ALERT SERVICE BULLETIN

DOORS – Sliding doors

Inspection of the upper rail and roller of the LH and/or RH sliding doors

[ASB AS350-52.00.54](#)

Figure 1

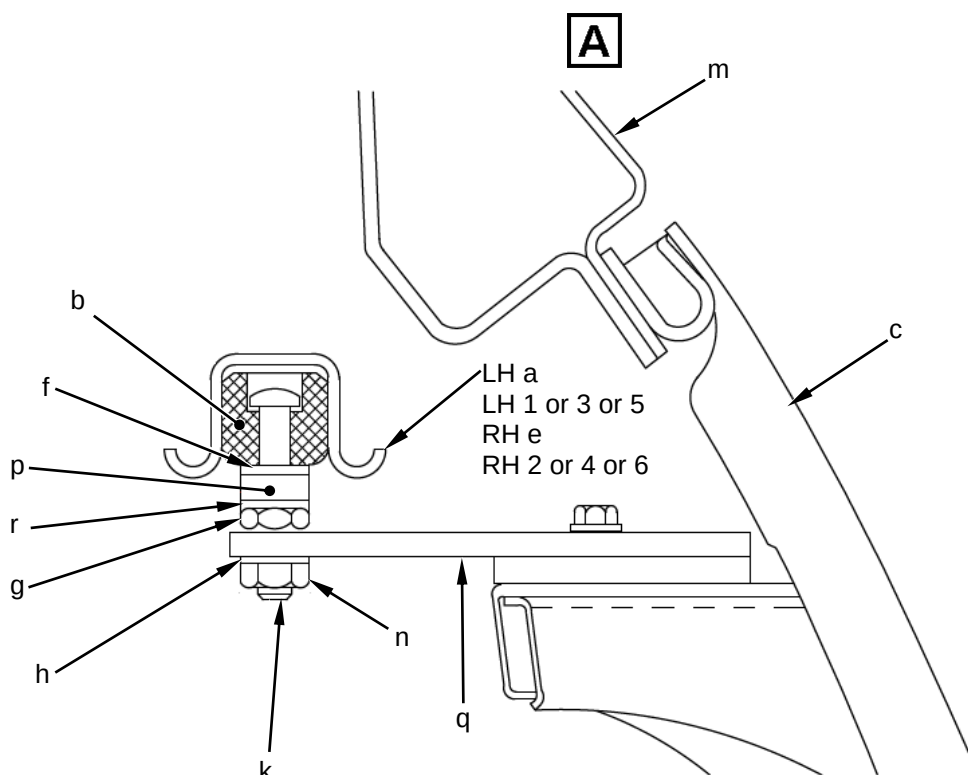
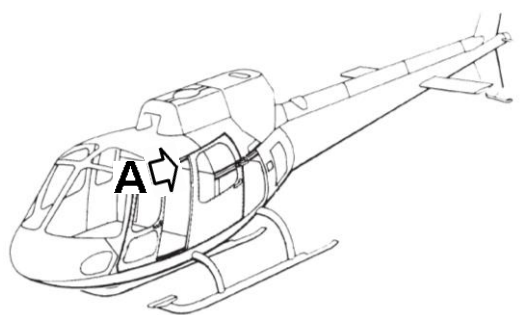
- Check the upper rail (a) ((e) for the RH side) as per Work Card 52-91-10-601 (MET) or Task 52-12-00, 6-1 (AMM).
- . If necessary, replace the upper rail (a) by an upper rail (1) or (3) or (5) ((e), (2) or (4) or (6) for the RH side) as per Work Card 52-12-01, 4 (SRM) or 52-91-10, 01 (MRS).
- . If necessary, adjust the sliding door (c) as per Work Card 52-91-10-501 (MET) or Task 52-12-00, 5-1 (AMM).
- Make sure that the parallelism between the sliding door (c) and its frame (d) (not shown) does not exceed 1.5 mm (.059 in) on a length of 1200 mm (47.24 in) as per Work Card 52-91-10-501 (MET) or Task 52-12-00, 5-1 (AMM).

- Remove the sliding door (c) as per Work Card 52-91-10-401 (MET) or Task 52-12-00, 4-1 (AMM).
- Make sure that the front roller (b) is in good condition, in compliance to the specific criteria as per Work Card 52-91-10-601 (MET) or Task 52-12-00, 6-1 (AMM).
- . If necessary, replace the front roller (b) by a front roller as per Work Card 52-91-10-403 (MET) or Task 52-12-00, 4-3 (AMM).

- Make sure of the correct stacking under the front roller (b) as per Detail A.
- On the screw (k) there are:
 - . the front roller (b),
 - . the washer (f),
 - . the spring washer (p),
 - . the washer (r) and the nut (g).
- The whole, front roller (b), washer (f), spring washer (p), washer (r), and the nut (g) are on the bracket (q) using the washer (h) and the nut (n).
- If necessary, correctly install the front roller (b) as per Work Card 52-91-10-403 (MET) or Task 52-12-00, 4-3 (AMM).
- Install the sliding door (c) as per Work Card 52-91-10-401 (MET) or Task 52-12-00, 4-2 (AMM).
